**National Committee on  
Seismic Design Parameters (NCSDP)  
for River Valley Projects**

**MINUTES  
OF  
26<sup>th</sup> MEETING  
(11<sup>th</sup> December, 2013)**

**MINUTES OF THE 26<sup>TH</sup> MEETING OF  
NATIONAL COMMITTEE ON SEISMIC DESIGN PARAMETERS FOR RIVER VALLEY PROJECTS  
HELD ON 11<sup>TH</sup> DECEMBER, 2013 IN CWC, NEW DELHI**

#### (a) Response Spectra

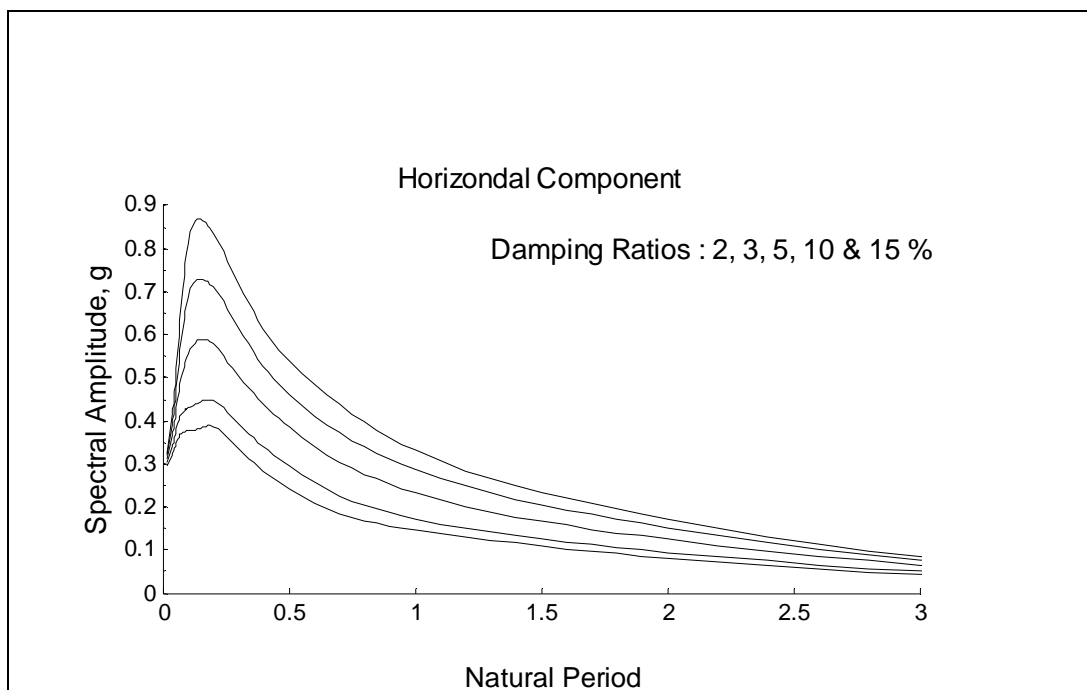
A presentation on the study report was made by the project authorities. **The Committee approved the study report of Dhaulasidh HE Project, Himachal Pradesh incorporating the revised seismic design parameters arrived as per Committee's decisions under item 26.1 and as summarized below:**

Max. Credible Earthquake Magnitude	7.0	Epicentral distance (km)	4	Focal depth (km)	15
Horizontal seismic co-efficient ( $\alpha_h$ )	0.24		Vertical seismic co-efficient ( $\alpha_v$ )		0.16
Strong motion duration (sec)	7		Total duration (sec)		36
Report reference	IIT Roorkee Report No. EQ: 2012-34 [(Project No. EQD-3022/2011-2012 (November-2012)] along with letter dated EQD/NCSDP/113 dated 11.03.2014 indicating revised parameters.

#### (a) Response Spectra

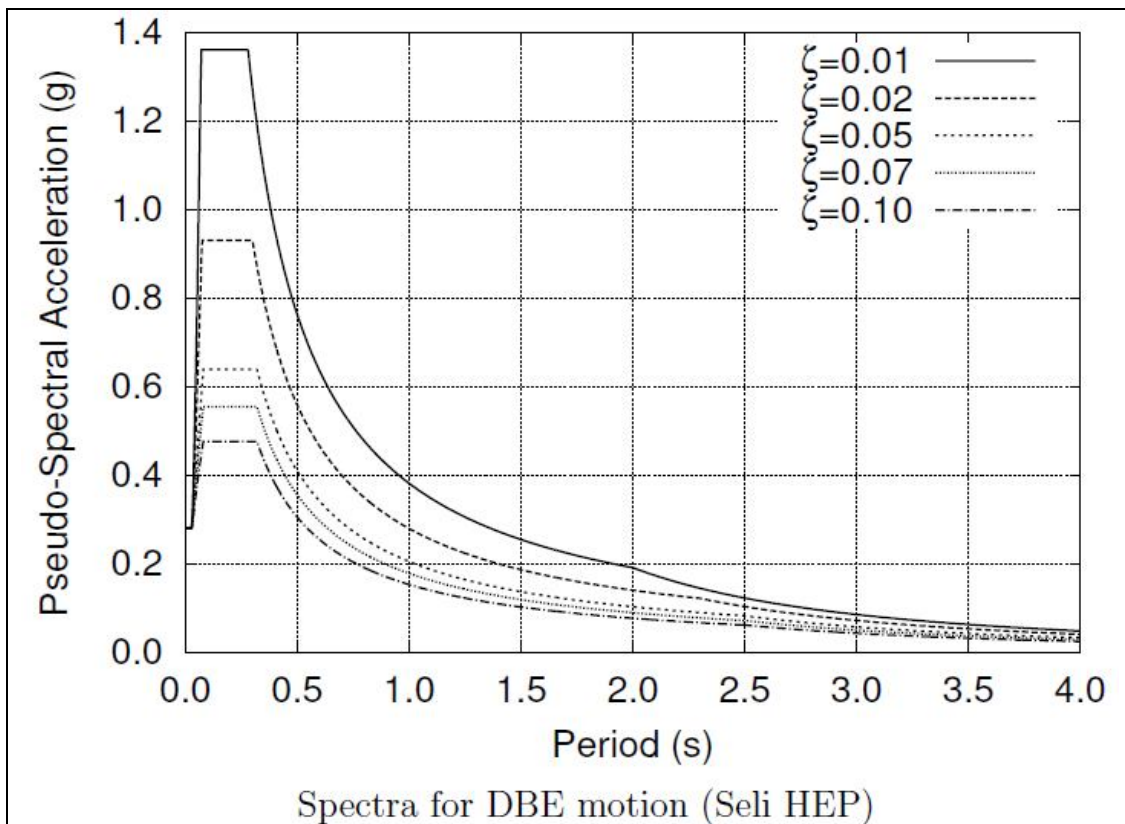
The Committee approved the study report of Chamkarchu (stage-I) HE Project, Bhutan incorporating the revised seismic design parameters arrived as per Committee's decisions under item 26.1 and as summarized below. The Committee also noted that its approval is conditional subject to the submission of MEQ studies by the project authorities by end of December, 2014:

Max. Credible Earthquake Magnitude	8.0	Epicentral distance (km)	-	Focal depth (km)	36.6
Horizontal seismic co-efficient ( $\alpha_h$ )	0.24	Vertical seismic co-efficient ( $\alpha_v$ )			0.16
Strong motion duration (sec)	11.8	Total duration (sec)			46.1
Report reference	Revised Technical Report No. 4892 (October-2011) of CWPRS furnished vide their letter no. 324/12/2011-ES/70/388 dated 12.02.2014.

##### (a) Response Spectra

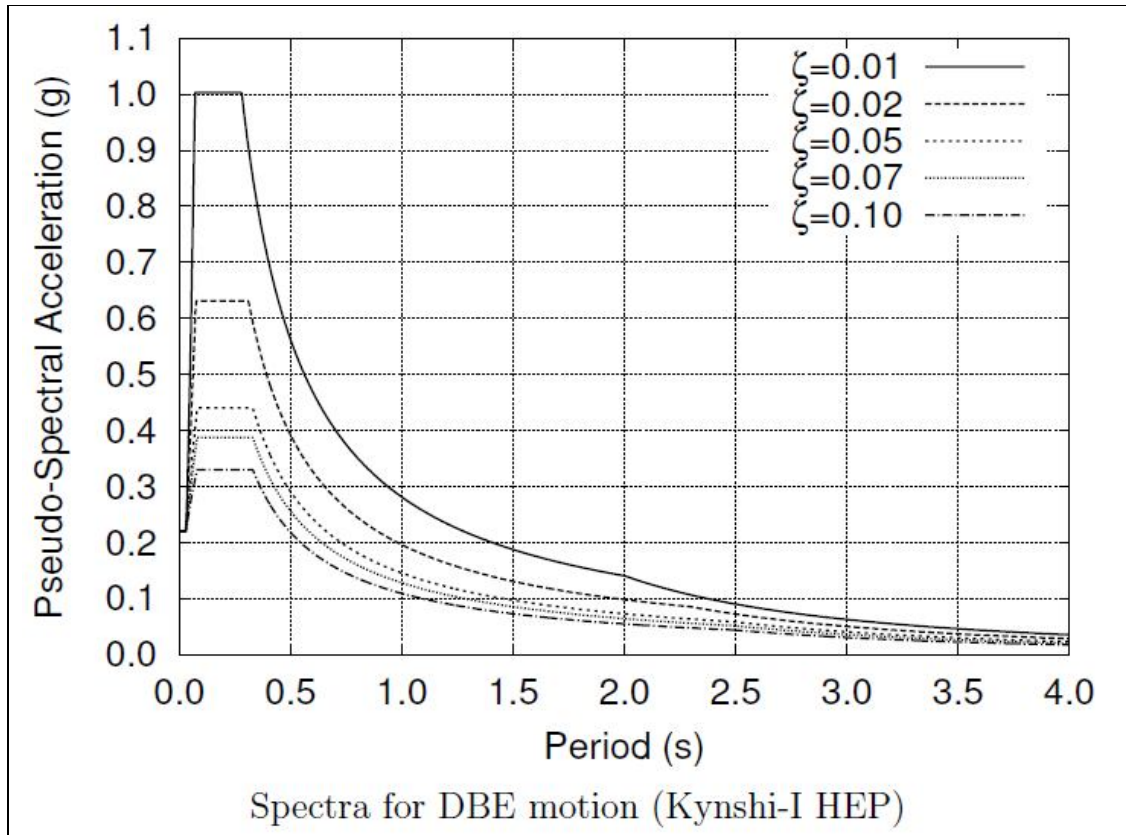
The Committee approved the study report of Seli H.E. Project, Himachal Pradesh incorporating the revised seismic design parameters arrived as per Committee's decisions under item 26.1 and as summarized below. The Committee also noted that its approval is conditional subject to the submission of MEQ studies by the project authorities by end of December, 2014.

Max. Credible Earthquake Magnitude	7.5	Epicentral distance (km)	5	Focal depth (km)	15
Horizontal seismic co-efficient ( $\alpha_h$ )		0.17	Vertical seismic co-efficient ( $\alpha_v$ )		0.11
Strong motion duration (sec)		8	Total duration (sec)		36
Report reference:	IIT Roorkee Report No. EQ: 2013-23 [(Project No. EQD-6019/12-13 (September-2013)] along with letter no. EQD/NCSDP/113 dated 11.03.2014 indicating revised parameters.

#### (a) Response Spectra

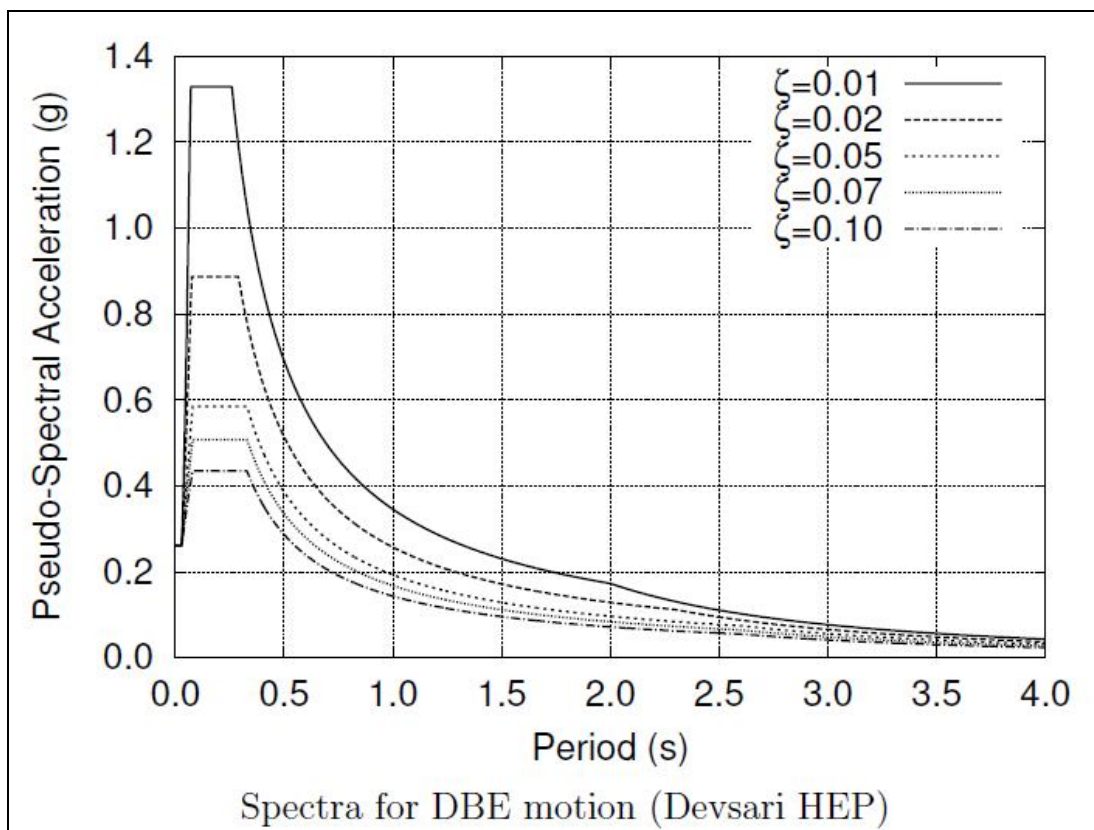
A presentation on the study report was made by the project authorities. **The Committee approved the study report of Devsari HE Project, Uttarakhand incorporating the revised seismic design parameters arrived as per Committee's decisions under item 26.1 and as summarized below:**

Max. Credible Earthquake Magnitude	8.0	Epicentral distance (km)	22	Focal depth (km)	15
Horizontal seismic co-efficient ( $\alpha_h$ )		0.24	Vertical seismic co-efficient ( $\alpha_v$ )		0.16
Strong motion duration (sec)		10	Total duration (sec)		51
Report reference	IIT Roorkee Report No. EQ: 2013-16 [(Project No. EQD-6014/2012-2013 (May-2013)] along with letter no. EQD/NCSDP/113 dated 11.03.2014 indicating revised parameters.

#### (a) Response Spectra

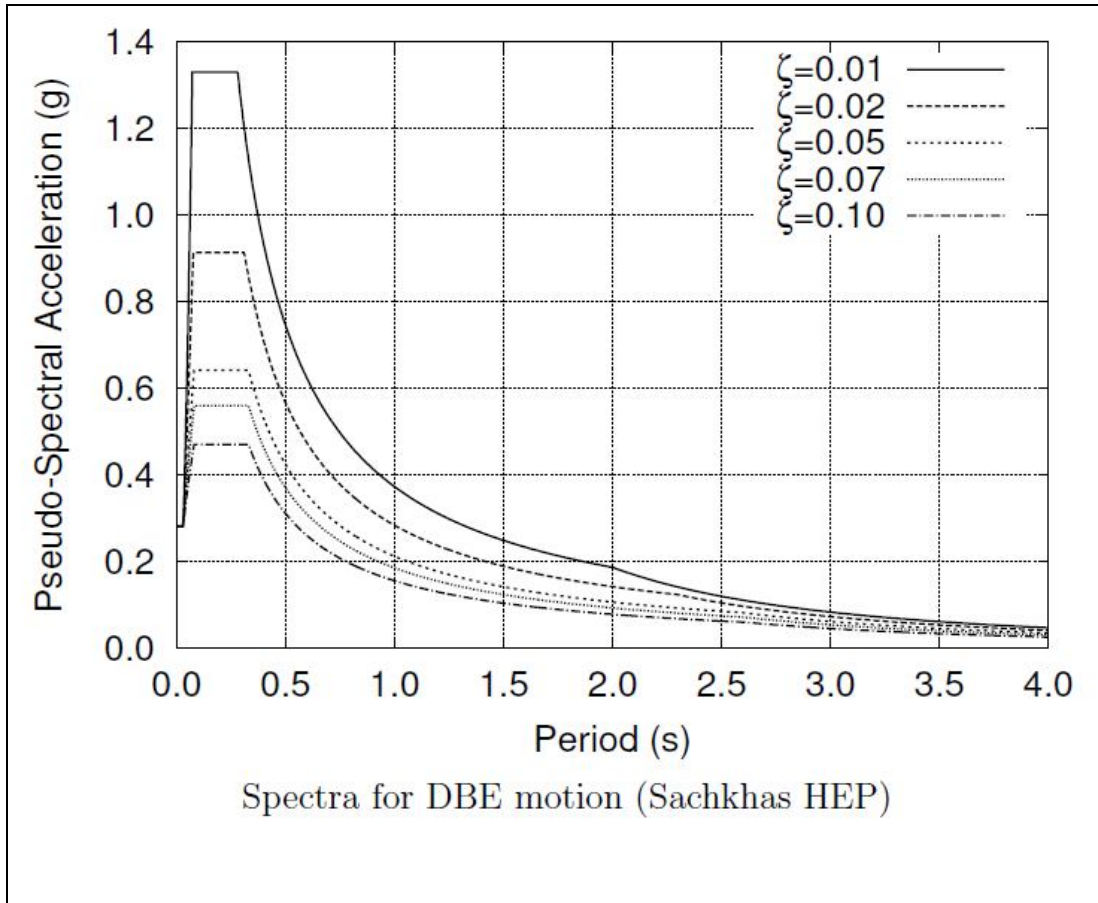
A presentation on the study report was made by the project authorities. **The Committee approved the study report of Sach Khas HE Project, Himachal Pradesh incorporating the revised seismic design parameters arrived as per Committee's decisions under item 26.1 and as summarized below:**

Max. Credible Earthquake Magnitude	7.5	Epicentral distance (km)	5	Focal depth (km)	15
Horizontal seismic co-efficient ( $\alpha_h$ )		0.17	Vertical seismic co-efficient ( $\alpha_v$ )		0.11
Strong motion duration (sec)		8	Total duration (sec)		43
Report reference	IIT Roorkee Report [(Project No. EQD-3021/2011-2012 (December -2012)] along with letter no. EQD/NCSDP/113 dated 11.03.2014 indicating the revised parameters.

Spectra for DBE motion (Sachkhas HEP)

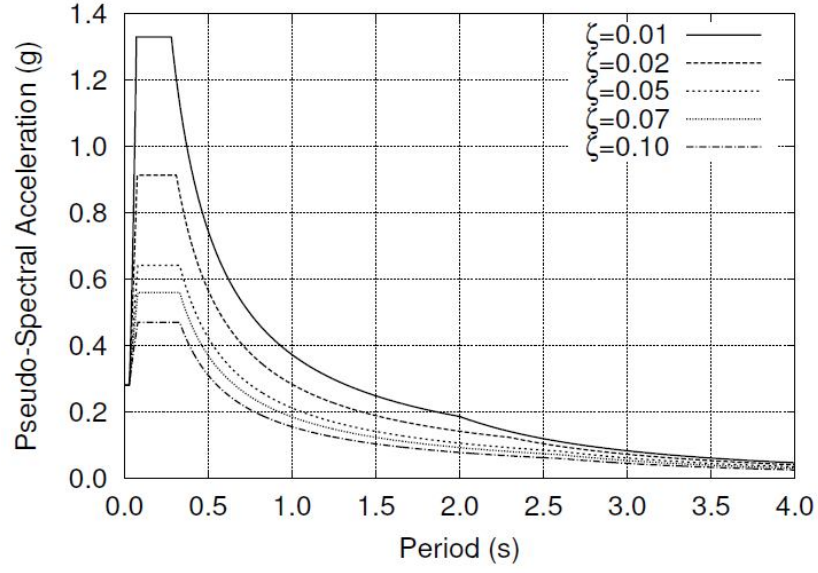
**Sachkhas HEP** The estimated seismic coefficients are:  $\alpha_h = 0.17$  and  $\alpha_v = 0.11$ . Strong motion duration: 8 s and Total duration: 43 s.

Spectra for DBE motion (Devsari HEP)

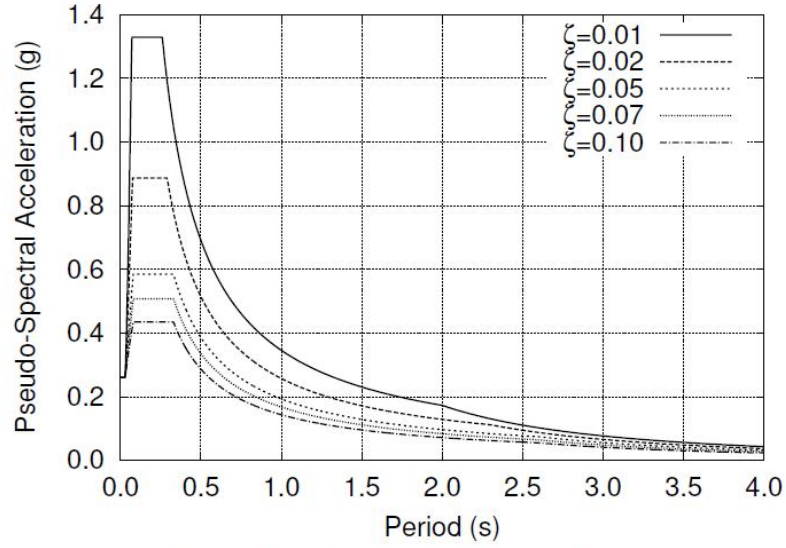
**Devsari HEP** The estimated seismic coefficients are:  $\alpha_h = 0.24$  and  $\alpha_v = 0.16$ . Strong motion duration: 10 s and Total duration: 51 s.

Spectra for DBE motion (Kynshi-I HEP)

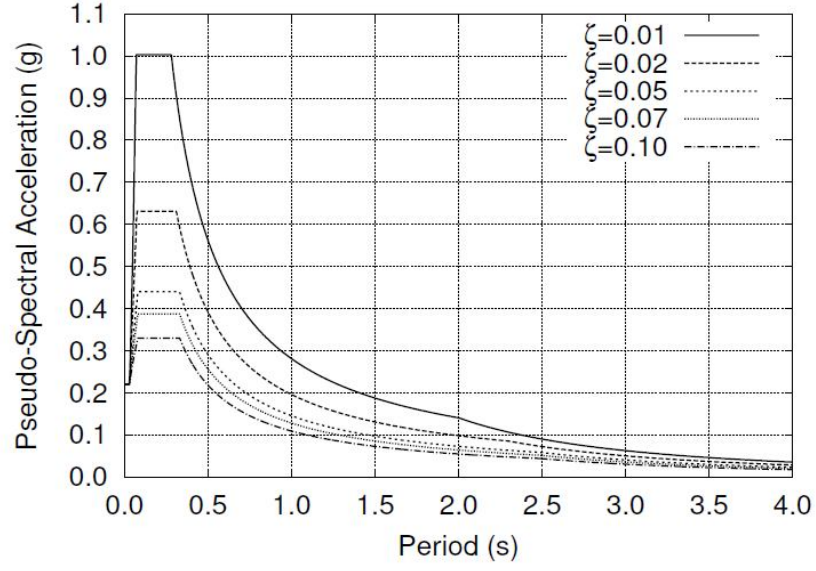
**Kynshi-I HEP** The estimated seismic coefficients are:  $\alpha_h = 0.24$  and  $\alpha_v = 0.16$ . Strong motion duration: 10 s and Total duration: 51 s.

Spectra for DBE motion (Seli HEP)

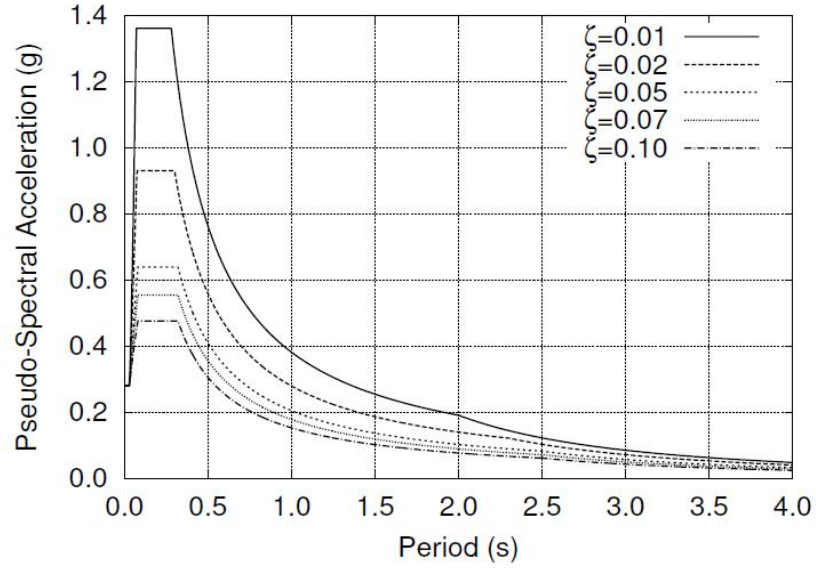
**Seli HEP** The estimated seismic coefficients are:  $\alpha_h = 0.17$  and  $\alpha_v = 0.11$ . Strong motion duration: 8 s and Total duration: 36 s.

Spectra for DBE motion (Dhauasidh HEP)

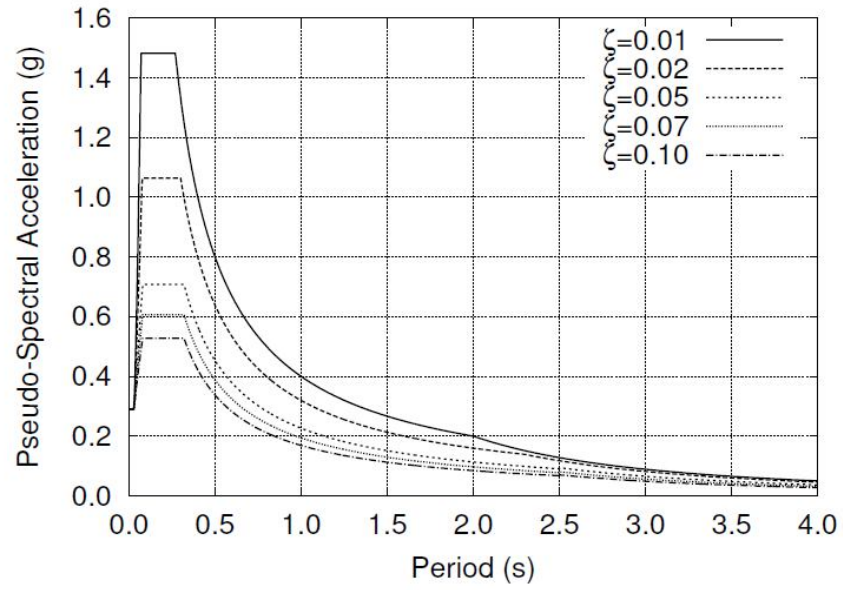
**Dhauasidh HEP** The estimated seismic coefficients are:  $\alpha_h = 0.24$  and  $\alpha_v = 0.16$ . Strong motion duration: 7 s and Total duration: 36 s.
